GE Hitachi Nuclear Energy

MFN 06-191
Supplement 8

Subject: Response to Portion of NRC Request for Additional Information Letter No. 166 Related to ESBWR Design Certification Application – Seismic Category I Structures – RAI Number 3.8-25 S05

RAI Number 3.8-25 S05

Figure 3.8-25(1) Rigid Bar Elements between Concrete and Liner

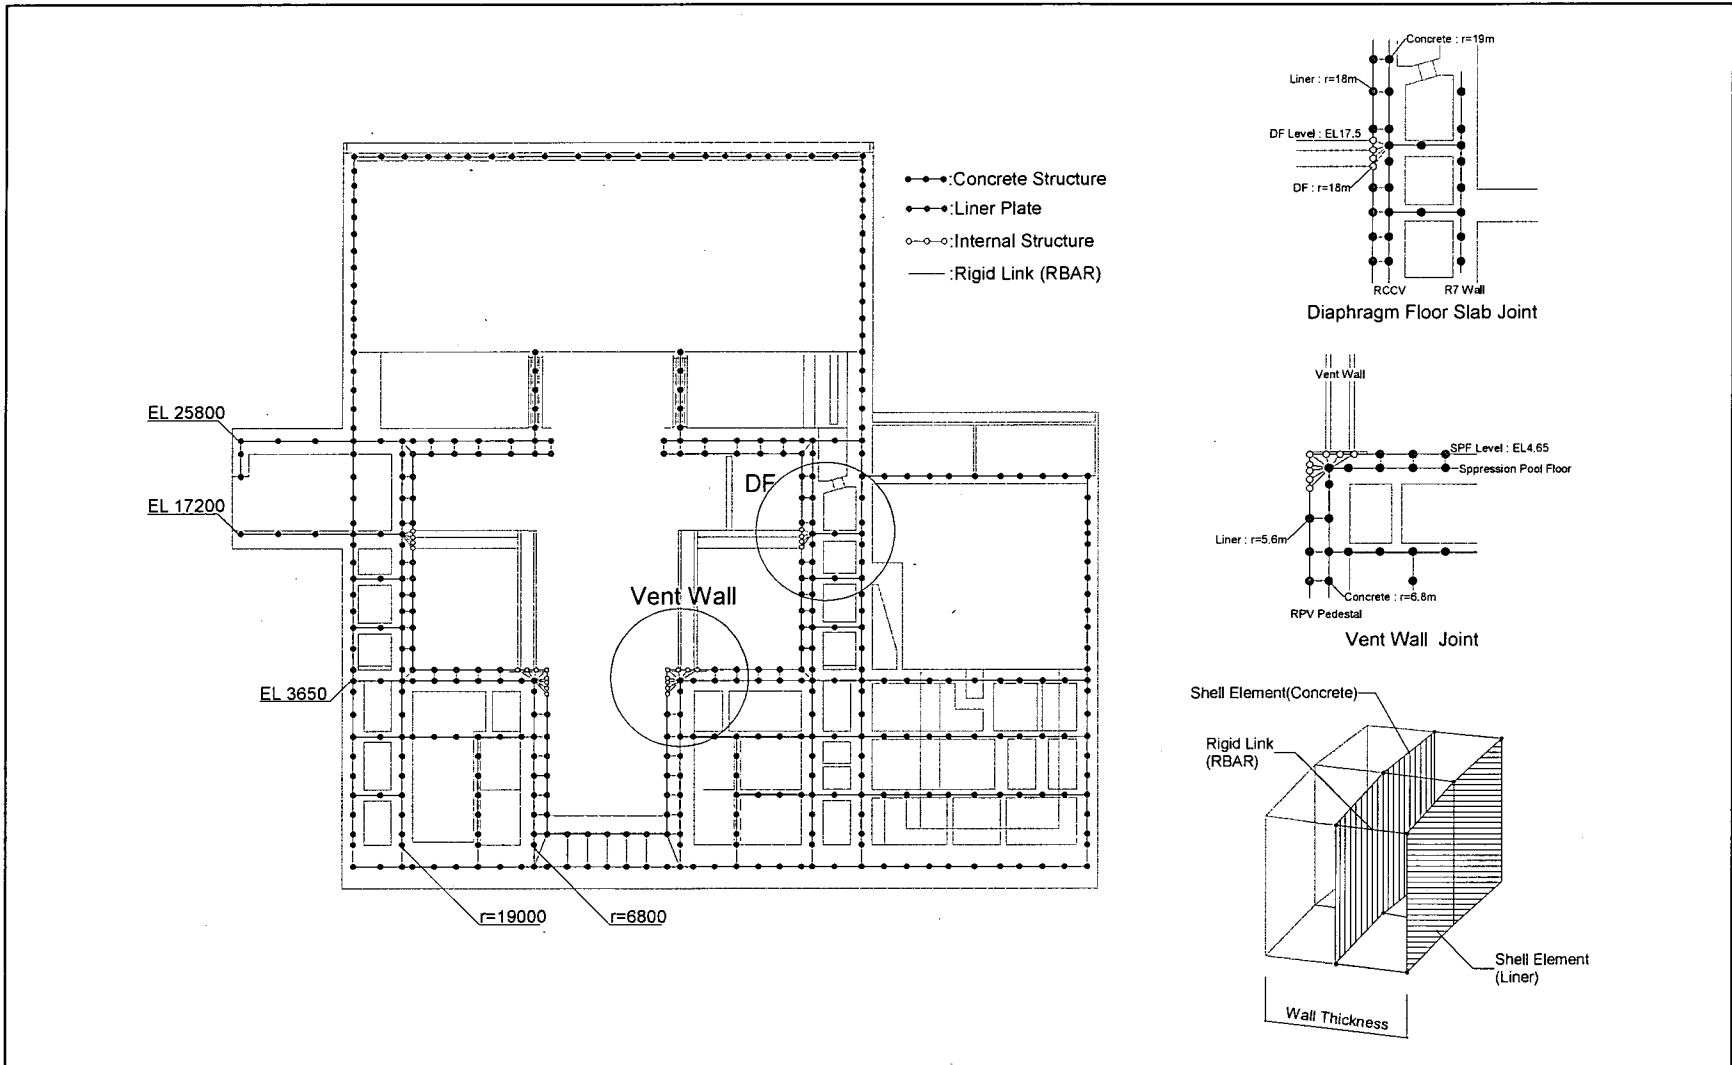
Describe how the analysis of a typical liner plate-to-RCCV attachment is performed using the NASTRAN model results. Include this information in DCD Section 3.8.1 and/or Appendix 3G.

Rigid bar elements connect the corresponding grid points of the liner elements and concrete elements as described in DCD Appendix 3G.1.4.1. They are schematically shown in Figure 3.8-25(1). To represent the anchor, rigid bar elements are placed in the radial direction for the liners of the RCCV cylinder wall and the RPV pedestal. They are placed vertically for the basemat, the suppression pool slab, and the top slab.

Using this modeling technique, the design forces of liner plates are obtained from the analysis directly, and the anchorage design is performed in accordance with ACI 349-01 Appendix B.

Figure 3.8-25(2) Analysis Models

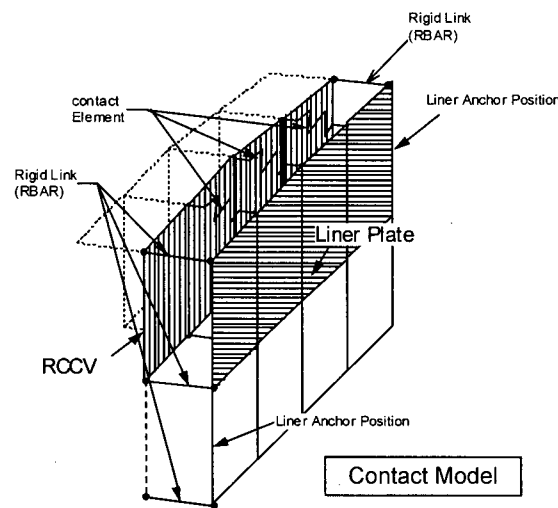
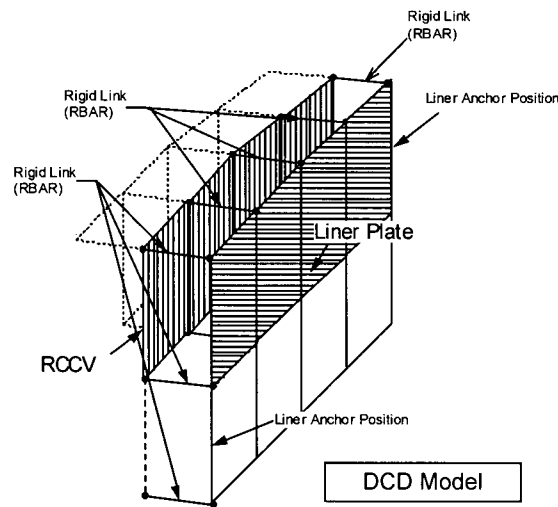
Further detailed review needed to fully understand the analysis study performed and to identify specific areas of the description, figures and tables (in the Supplement No. 2 response) which require further clarification. For example, the text indicates that Case 1 is provided to simulate the DCD design technique. However, the table provided for Case 1 - a and -b calls this model "Glued." The DCD and prior discussions with GE seem to indicate that the DCD model is not glued but free to deform between attachment points (rigid links). The concerns raised under this RAI are closely associated with RAI 3.8-26. Additional staff evaluation is also needed to understand the methodology used for analysis of the liner anchors.

"Glued" means all concrete and liner nodes are rigidly linked regardless of actual liner anchor locations. This is consistent with the DCD and prior discussions indicating that the DCD model is free to deform between attachment points (nodes).

In order to avoid confusion, the word "glued" used in the NRC RAI 3.8-25, Supplement 2 response is revised to read "DCD," as show in the following "FEM Analysis for Liner Plates" analysis:

The width of the model is twice the Liner anchor pitch (2 x 5.14 degrees) and the height is the half of width. Six degrees of freedom of nodes provided for liner are subordinations to these of RC wall. Figure 3.8-25(2) shows the analysis models.

Figure 3.8-25(5) Analysis Models

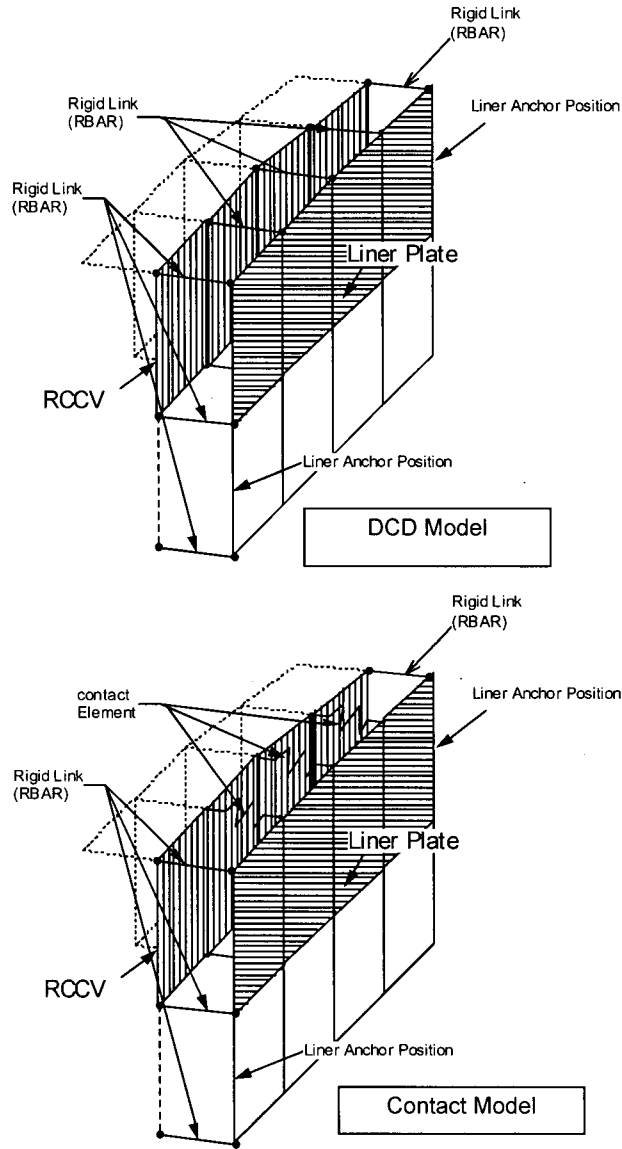
From the information provided in the response, it is not clear whether the comparative analysis between the small "DCD Model" and the "Contact Model" addresses this issue. The two models appear to be basically the same, except that each rigid link was replaced by a contact element. Therefore, it is not surprising that the liner strains are the same. The applicant should indicate whether the small DCD Model represents the exact concrete, liner, and rigid link modeling configuration used in the full DCD building model. This should include confirmation of the horizontal and vertical spacing of the rigid links and whether this model represents the most critical location (e.g., where spacings between rigid links are large). Also, from the information provided it is not clear that the existing contact model had a sufficient number of contact elements and liner plate elements (with additional nodes in the plate elements between the contact elements) to properly simulate the true design configuration that will be constructed. The comparison of responses should also include a tabulation of maximum strains (membrane and membrane plus bending) and reaction loads at key liner anchor locations.

2. The section "FEM Analysis for Liner Plates" provided in NRC RAI 3.8-25, Supplement 1, 2 and 3 has been updated as shown in the following section to match the exact upper drywell liner anchor spacing of 1.6° (see DCD Tier 2 Figure 3G.1-48).

Additionally, to evaluate the mesh size effect, a sensitivity analysis is performed with a refined Contact Model in which the number of contact elements and liner plate elements is twice of that in the existing Contact Model. The results of the refined Contact Model are the same as the original Contact Model as shown below.

The width of the model is twice the liner anchor pitch (2 x 1.6 degrees) and the height is the half of the width. Six degrees of freedom of nodes provided for liner are subordinations to these of the RC wall. Figure 3.8-25(5) shows the analysis models. The RCCV wall is modeled in the center of the wall thickness and the liner is placed on the position of the RCCV wall surface.

Figure 3.8-25(8) Area of Models

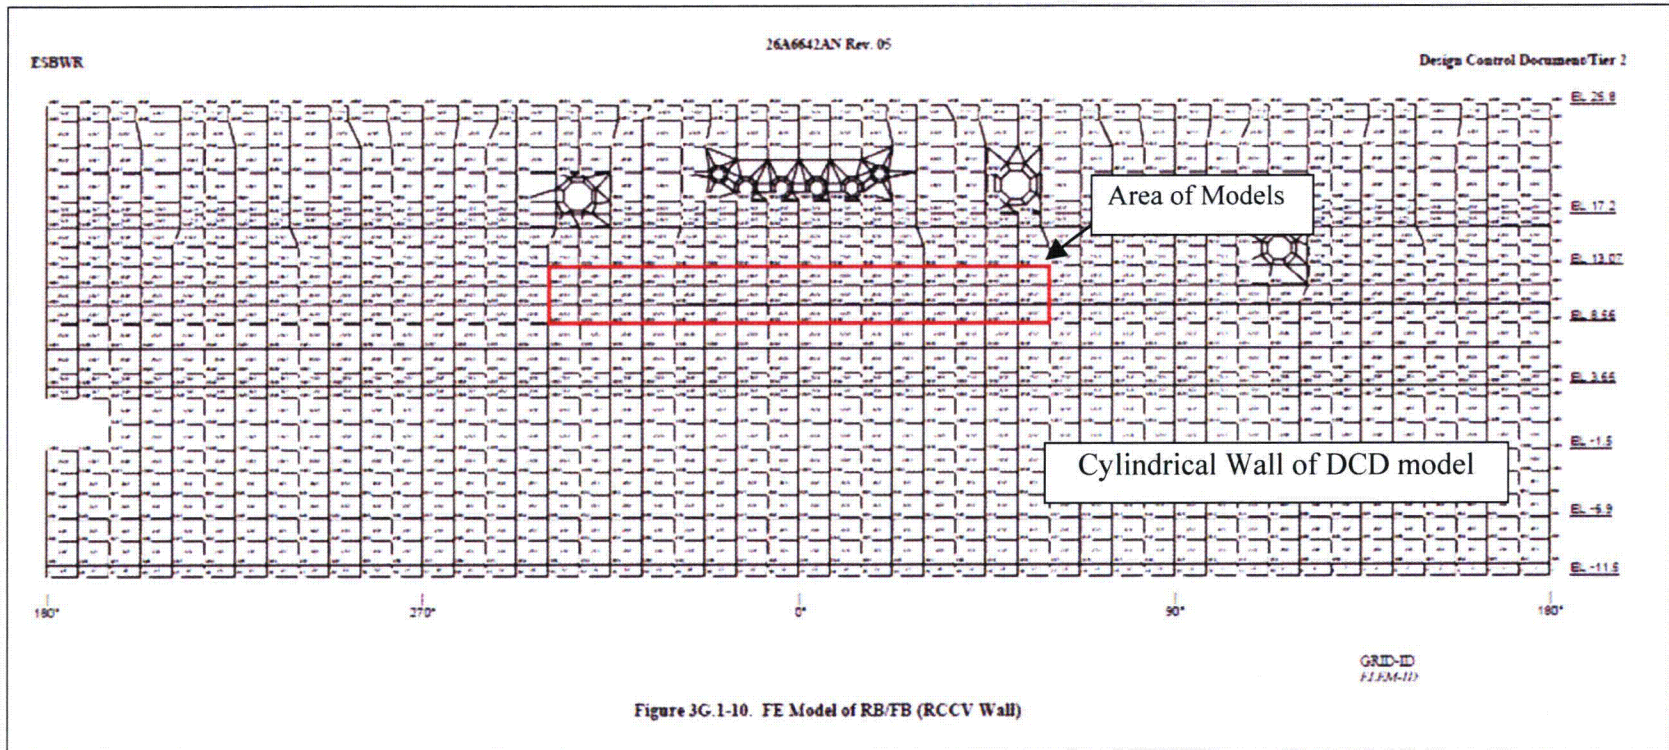
(1) *The response, transmitted in GEH letter dated December 12, 2007, provided some information regarding the analysis of the containment liner plate in the full DCD NASTRAN building model. The information provided in the analytical study of a small portion of the containment wall however, did not address the major concerns raised in the RAI. The small "DCD model" was analyzed and compared to the "contact model" which showed the same strains and reaction forces at the liner anchors. However, under pressure loads the two models are essentially identical and so the strains and anchor loads are expected to be the same. This is similarly true for the thermal loading case. Therefore, it does not appear that the study addresses the concerns raised in the RAI.*

It was expected that GEH would configure the small DCD model to be identical to the actual full DCD model configuration; that is, it would match the presumed coarser spacing of finite elements with rigid links used in the full DCD model regardless of the actual liner anchor locations. The contact model should then confirm the accuracy of the small DCD model configuration by using a finer discretization (i.e., more finite elements) spaced between the actual locations of the liner anchors. For this contact model, the use of rigid links at the actual anchor locations in both horizontal and vertical directions and the use of contact elements at all other node locations would be acceptable. These two models would not match each other as they do in the current study submitted in the supplemental response.

Based on the above, GEH is requested to revise the analytical models or explain how the current study in the RAI response addresses the potential differences between the current liner model in the full DCD model (which does not match the actual liner anchor spacing and has a presumably coarser distribution) and the true liner configuration with actual anchor spacings.

(1) The small DCD model is updated so that it is identical to the actual full DCD model configuration. Figure 3.8-25(8) shows the modeling area for the updated small DCD model extracted from the actual DCD model. The contact model is also updated to cover the same region as the small DCD model. The contact model uses a more refined mesh and takes into account the actual liner anchor locations spaced at 1.6 degrees apart. The entire range of both models is 120 degrees in the circumferential direction with element spacing at 7.5 degrees in the small DCD model and 0.8 degrees in the contact model.

The modeling area is a 120-degree segment of the actual full DCD model as shown in Figure 3.8-25(8). In the small DCD model, the standard width of elements is 7.5 degrees in the circumferential direction and rigid links are used to connect the concrete and liner nodes regardless of the actual anchor locations. A refined element width of 0.8 degrees is used in the contact model, in which rigid links are used only at the actual anchor locations spaced at 1.6 degrees apart and contact elements are used in the non-anchored areas. Figure 3.8-25(9) shows the analysis models. The RCCV wall is modeled in the center of wall thickness and the liner plate is placed at the inner surface of the RCCV wall.

Figure 3.8-25(12) Bending Strain of Liner Plate

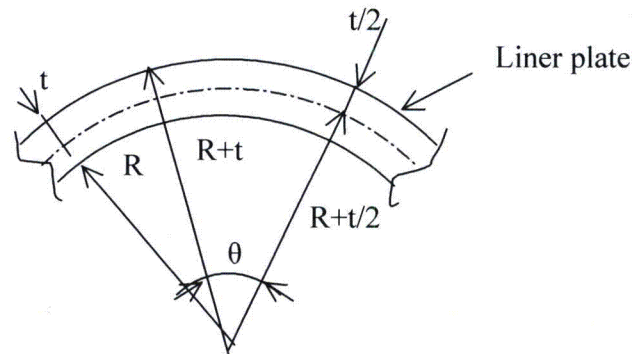
- a. *How are the strains tabulated in DCD Table 3G.1-35 determined? Are they obtained directly from the individual finite elements of the full DCD NASTRAN model and are they the maximum membrane and maximum membrane plus bending strain acting in any direction throughout the thickness of the liner plate?*

- a. The strains tabulated in DCD Tier 2 Table 3G.1-35 are obtained directly from the individual finite elements of the full DCD NASTRAN model and they are the maximum principal membrane strains. Bending strains of liner plate are very small. For example, membrane plus bending strain that corresponds to the maximum membrane strain of 0.0041 (high-precision number is 0.0040860) at the cylinder for the abnormal/extreme environment category, as shown in DCD Tier 2 Revision 5 Table 3G.1-35, is 0.0040915, so bending strain itself is only 0.0000055. This is 0.13% of membrane strain. And allowable strains for them, shown in ASME Section III, Division 2, Table CC-3720-1, are much larger than those for membrane plus bending strains. Therefore, membrane strains control the liner design.

Solving for ϵ_b using the following equation demonstrates that bending strains of liner plate are negligibly small: (See Figure 3.8-25(12) for an explanation of the below variables):

Since the radius of the RCCV is much larger than the liner thickness, the bending strain of the liner plate, $\epsilon_b = t/2R$, is negligibly small.

Figure 3.8-25(13) Analysis Model (4 Nodes Plane Strain Element)

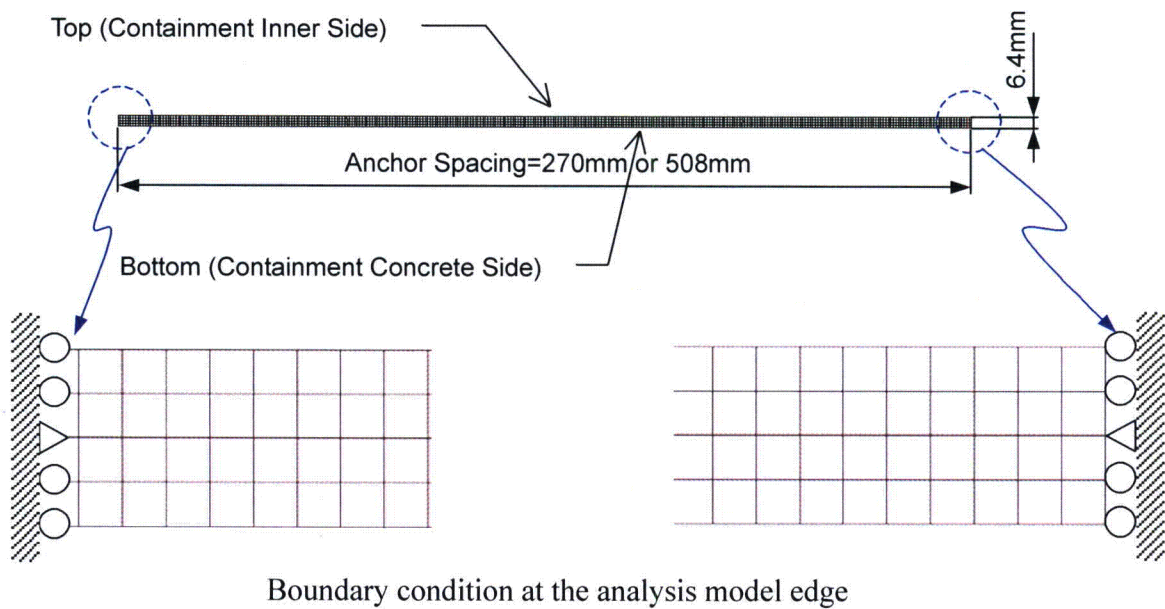
- b. *Since the NASTRAN analysis does not consider potential buckling of the liner plate, GEH is requested to explain if buckling of the liner can occur under the maximum calculated strains for the most critical anchor spacing configuration. If buckling can occur, then describe the calculation performed to obtain the strains in the buckled configuration and demonstrate that they still meet the allowable strain limits in the ASME Code. This should include consideration of the liner strains under thermal local effects on the containment liner due to design basis accident condition. Considering the time-dependent nature of the load, pressure loading may not be present to mitigate the buckling of the liner.*

- b. To evaluate liner buckling potential under DBA thermal load of 171°C, a separate finite element analysis using ABAQUS computer code is performed for the local liner model shown in Figure 3.8-25(13) for the following two anchor spacing cases: 508 mm (maximum spacing in the design) and 270 mm. The analysis is performed in two steps. The first step is an elastic buckling analysis. The calculated buckling mode shape is then scaled to simulate initial imperfection of the model in a subsequent elasto-plastic stress analysis under the DBA thermal load. The maximum initial imperfection considered is 0.1 mm for both anchor spacing cases. For the 508 mm spacing case, 0.2 mm and 0.64 mm (10% of the liner thickness) initial imperfection are also evaluated and the resulting liner strains are found to be smaller than the 0.1 mm initial imperfection case. The analysis results are shown in Table 3.8-25(10), Figure 3.8-25(14) and Figure 3.8-25(15). Figures 3.8-25(14) and 3.8-25(15) reveal that the liner would buckle when temperature reaches about 80°C and 47°C for the 270 mm and 508 mm anchor spacing, respectively. The maximum liner strains, summarized in Table 3.8-25(10), still meet the allowable limits of ASME Section III, Division 2, Subsection CC-3720.
